Bendigo/Ophir Gold Project Fast-track Approvals Application

Transportation Review

Prepared for	Central Otago District Council
Project Number	CODC-J026
Revision	A
Issue Date	20 March 2026
Prepared by	Logan Copland, Principal Transportation Planner; Dave Smith, Technical Director
Reviewed by	Dave Smith, Technical Director

Figure 1.3 Section of Thomson Gorge Road proposed to be stopped (between red lines). (Source: Additional info submitted 10 March 2026)

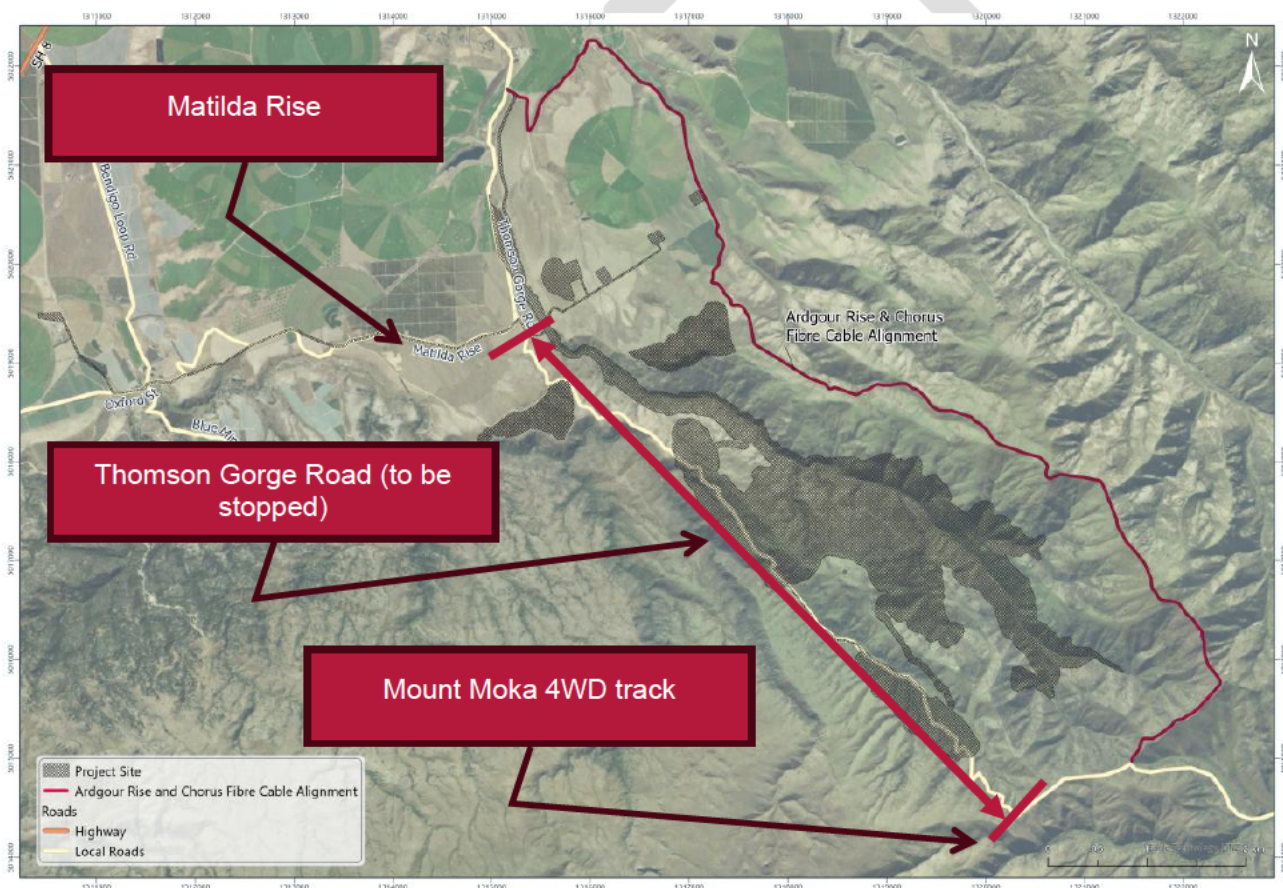
The BOGP footprint extends into the current Thomson Gorge Road corridor, and as a result, MGL seeks to “stop” that section of Thomson Gorge Road and construct a new road of a similar standard on a new alignment to maintain public access over the Dunstan Mountains. We understand the section of Thomson Gorge Road that is proposed to be stopped spans from just south of Matilda Rise at the northern end to the start of the Mount Moka 4WD track at the southern end, refer Figure 1.3. This is intended to ensure that access to the Mount Moka 4WD track is maintained from the southern end of Thomson Gorge Road in perpetuity. We understand that the road stopping process is being addressed outside of the resource consent application for the BOGP. We comment further on this aspect in Section 4.4 of this report.

Figure 1.4 BOGP context plan showing proposed Ardgour Rise alignment. (Source: Stantec ITA, marked up by Abley).

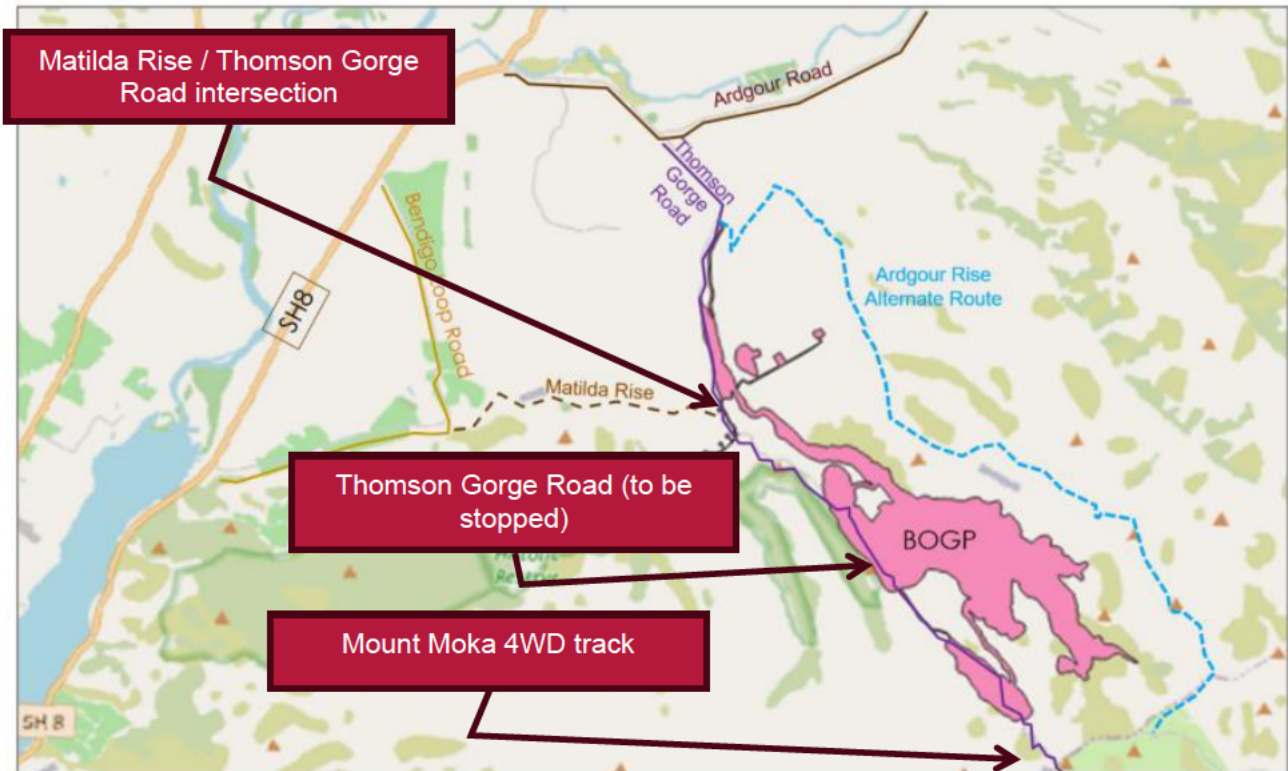
The proposed new alignment is referred to as “Ardgour Rise” and is shown in Figure 1.4. Ardgour Rise will increase the route length by approximately 1.2km, from the current circa 12.1km to circa 13.3km. 12km of the new route is shown to pass over Ardgour Station, and the remaining 1.3km is shown to

The timing of the construction of Ardgour Rise is stated to depend on when the new mine pit operations will disrupt the safe and through function of the existing Thomson Gorge Road alignment⁸.

Figure 4.2 Section of proposed Ardgour Rise alignment that passes over DOC Reserve

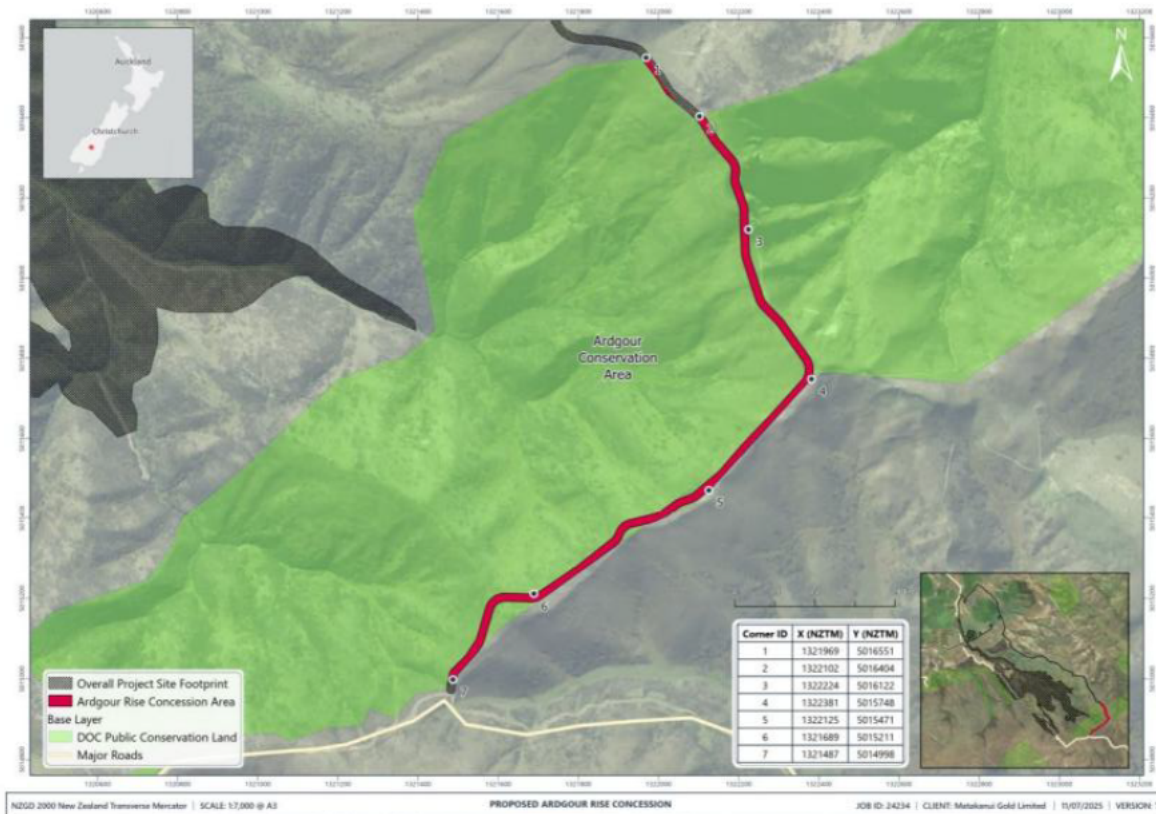
The details of the design of Ardgour Rise are yet to be confirmed, as is the exact alignment, which has been subject to separate discussions with DOC and CODC. We also understand that there remains an unresolved issue regarding the 1.3km section of Ardgour Rise that is shown to pass over DOC land, refer Figure 4.2.

Figure 1: Existing and Proposed Road Alignment

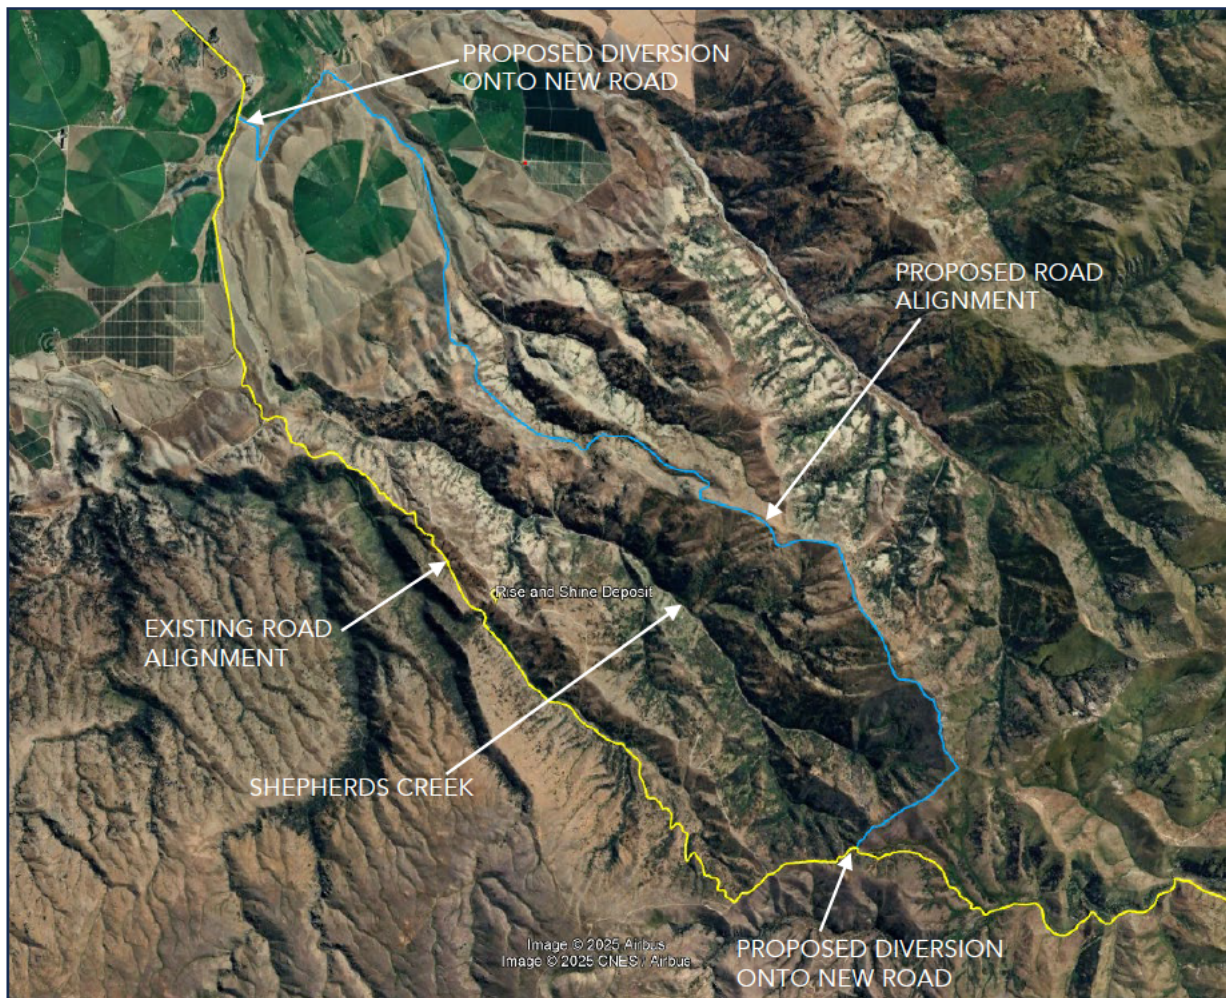
The proposed new route is show in Figure 1 below. The route follows a farm track from the

Ardgour Station Woolshed before heading south where it meets the foothills of the Dunstan Mountains. The route then generally follows a ridgeline on the east side of Shepherds Creek before crossing Thomsons Saddle and rejoining the existing Thomson Gorge Road. The southernmost 1.2km of the route is on Department of Conservation (DOC) land, the rest is on Ardgour Station land.

Figure 3: Extract from Standards for Gravel Roads showing a typical cross-section

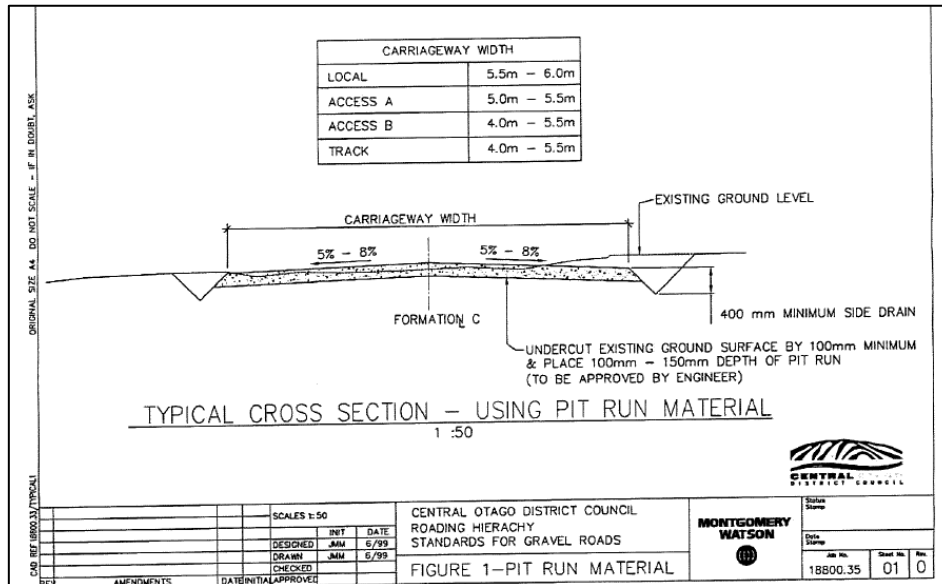
The plan provided does not include cross-section information. Any cross-section design should follow the guidance in the CODC Standards for Gravel Roads, specifically Table 1 of the standards. An extract showing the typical cross-section is included in Figure 4 below.

Figure 4: Extract from Standards for Gravel Roads for a cross-section using graded material (Option 1 above).

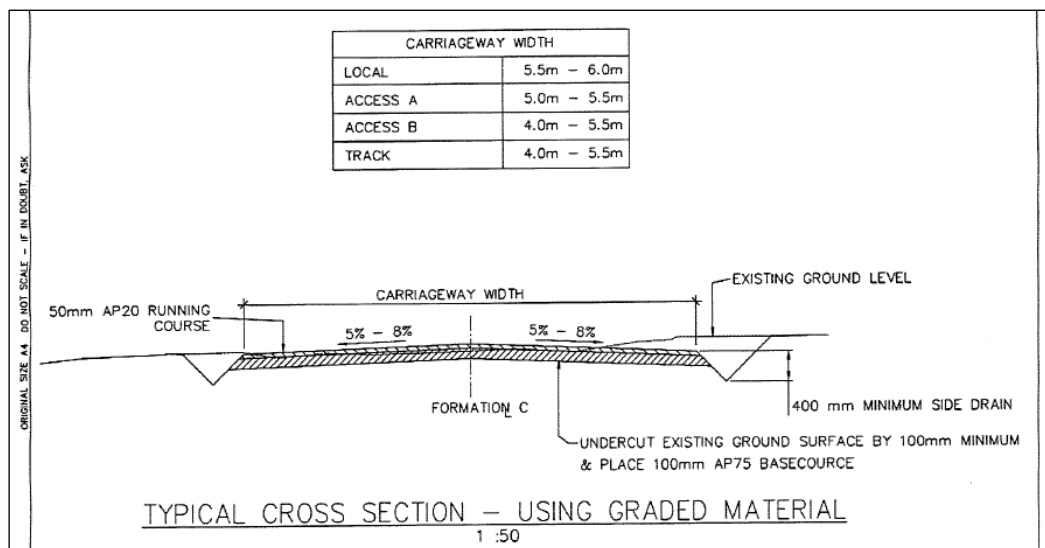
Of these two options we recommend Option 1, subject to an aggregate containing a clay fraction being used to produce the AP20 and the AP75. The presence of the clay will help keep the pavement bound during drier periods.

We recommend that at least the AP20 be produced by crushing to improve interlock and shear resistance. This will help the pavement maintain shape during wet periods.

PROPOSED THOMSONS TRACK ALIGNMENT ELEVATION PROFILE

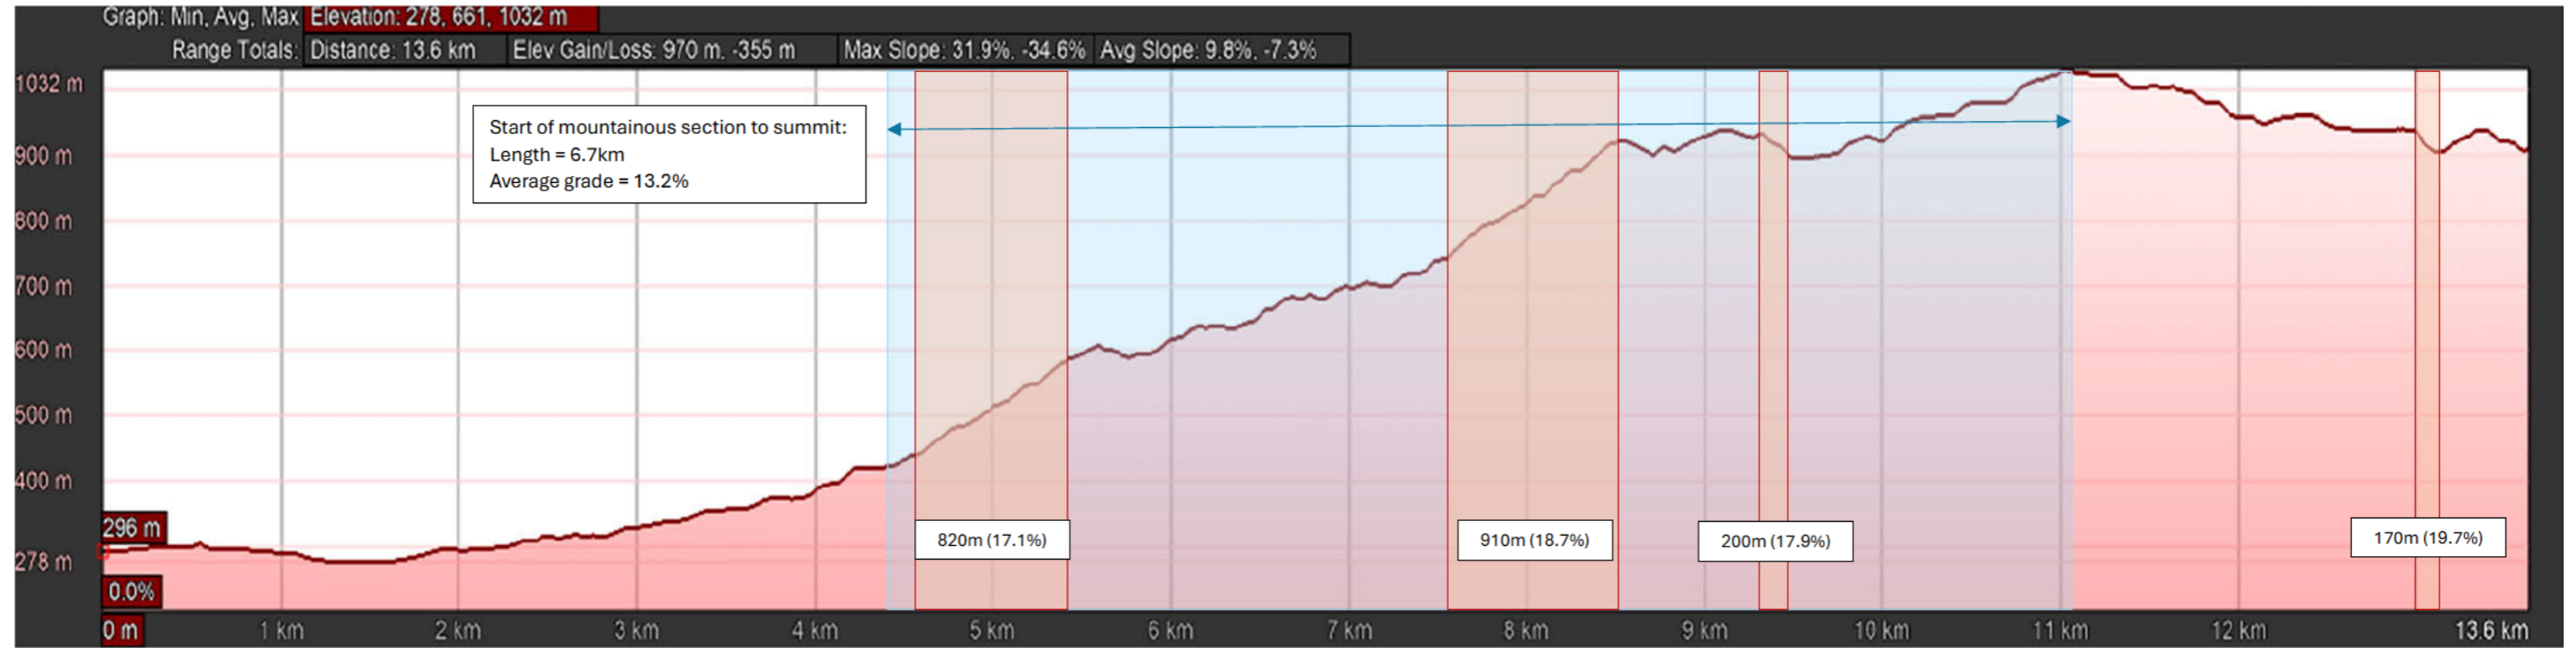
Note: Extract of elevation profile with steep sections highlighted.
